Safety Defect and Noncompliance Report Guide for Equipment
PART 573 Defect and Noncompliance Report

On April 12, 2012 Specialty Manufacturing, Inc. decided that a non-compliance with Federal Motor Vehicle Safety Standard No. FMVSS 217 exists in the motor vehicle equipment listed below and is furnishing notification to the National Highway Traffic Safety Administration in accordance with 49 CFR Part 573 Defect and Noncompliance Reports.

Generic name of the item: *ProLo Roof Hatch*

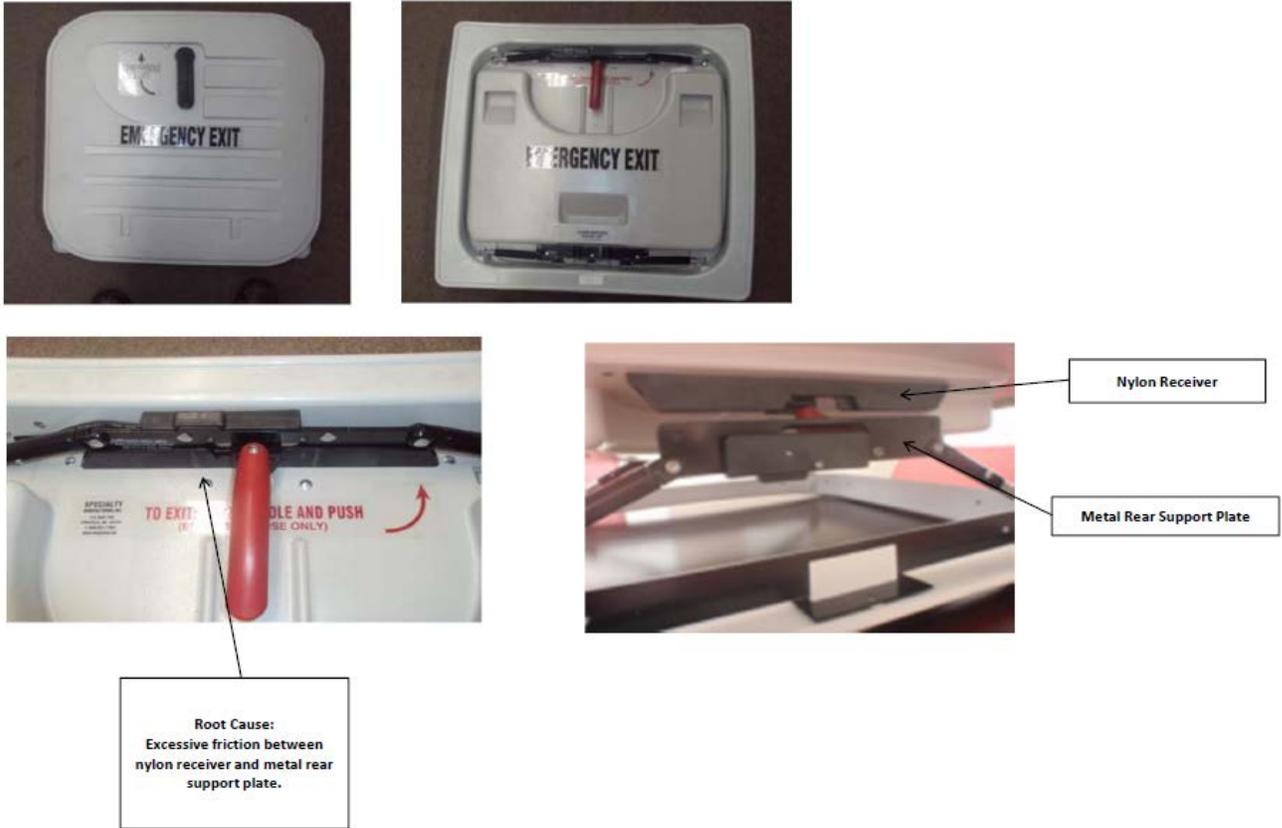
Of the two mating components involved in the noncompliance issue, the 008956 Nylon Receiver is an injection-molded part (shown in Section III, 5 below). This part was purchased from a single supplier from September 2008 until April 2011, at which time the part was sourced to a new supplier, Syracuse Plastics. This supplier change combined with continued wear of the tool resulted in undetected changes in the slot dimensions. The last shipment of 456 parts from the previous supplier was received on April 11, 2011 and part of this last shipment was mixed with the first shipment from the new supplier. While the earliest hatch build date containing this noncompliance is May 21, 2011, all hatches built from April 2011 until March 25, 2012 are suspect for this condition.

Increased friction between the 009327 Rear Plate Assembly and the 008956 Nylon Receiver results in an opening force on ProLo roof hatches that may exceed FMVSS 217 standards.

Continued wear of the tools over time for both the 008956 Nylon Receiver and the 009327 Rear Plate Assembly produced by SMI, combined with a change in suppliers for the 008956 Nylon Rear Pop-Up Support.

The force required to open the roof hatch may exceed the FMVSS 217-specified 40-pound maximum by forces ranging from 1 to 25 pounds with the average being 7 pounds.

Replacement of the 008956 Nylon Receiver resolves interference issues.

The two walls of the remedy 008956 Nylon Receiver are parallel on the remedy component producing a minimum slot width of 0.200". (The slot width on the recalled component narrows toward the center of the part and the part may be bowed along the length, exacerbating the interference with the 009327 Rear Plate Assembly.)
